TITLE
2022 DSDP - HOLLAND
87" HOME THEATER

DWG. NO.
CF7000520

REV.
D

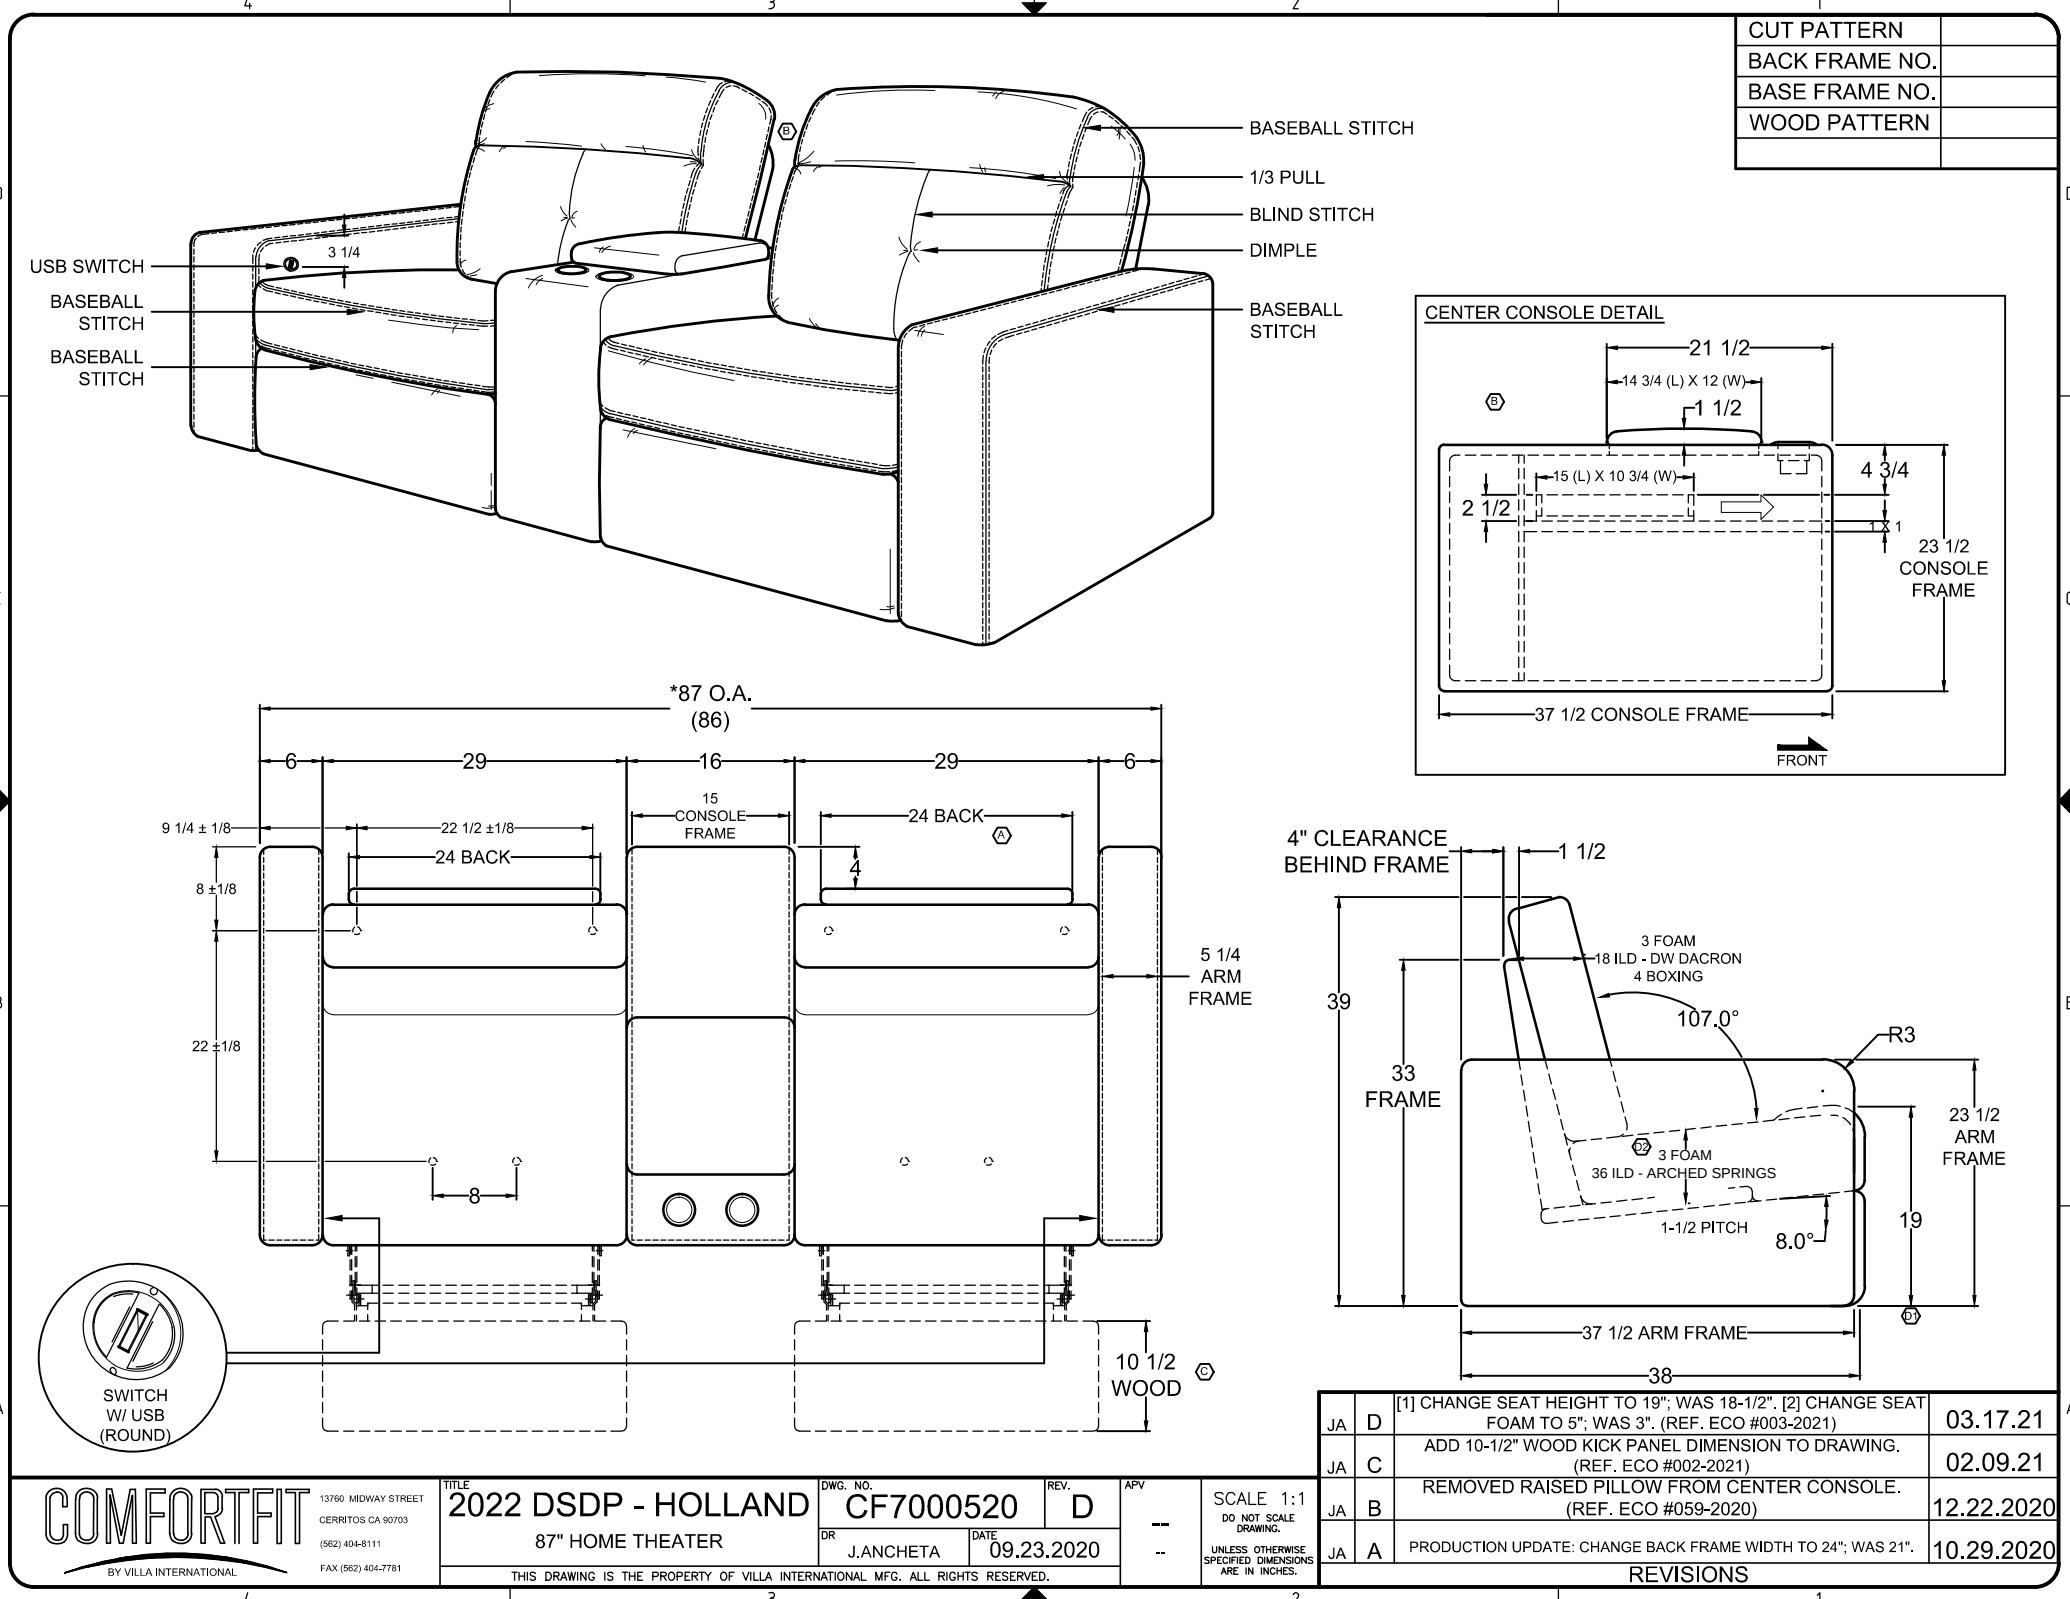
JA	D	[1] CHANGE SEAT HEIGHT TO 19"; WAS 18-1/2". [2] CHANGE SEAT FOAM TO 5"; WAS 3". (REF. ECO #003-2021)	03.17.21
JA	C	ADD 10-1/2" WOOD KICK PANEL DIMENSION TO DRAWING. (REF. ECO #002-2021)	02.09.21
JA	B	REMOVED RAISED PILLOW FROM CENTER CONSOLE. (REF. ECO #059-2020)	12.22.2020
JA	A	PRODUCTION UPDATE: CHANGE BACK FRAME WIDTH TO 24"; WAS 21".	10.29.2020
REVISIONS
